### **Addendum 149 – UN Regulation No. 150**

#### **Amendment 3**

### **Uniform provisions concerning the approval of retro-reflective devices and markings for powerdriven vehicles and their trailers**

Figure A24-II

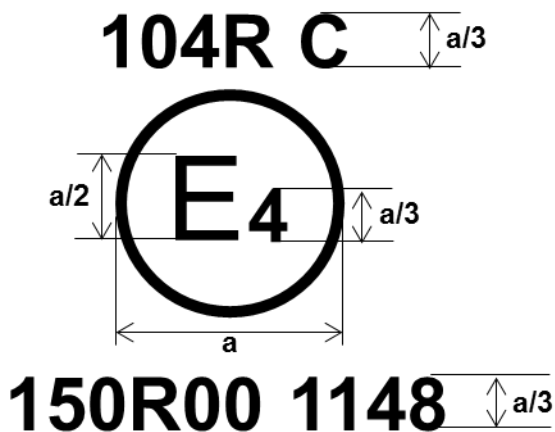
Annex 24, amend to read:

*Note:* The two examples of approval marks, models D and E, represent three possible variants of the marking of a lighting device when two or more lamps are part of the same unit of grouped, combined or reciprocally incorporated lamps.
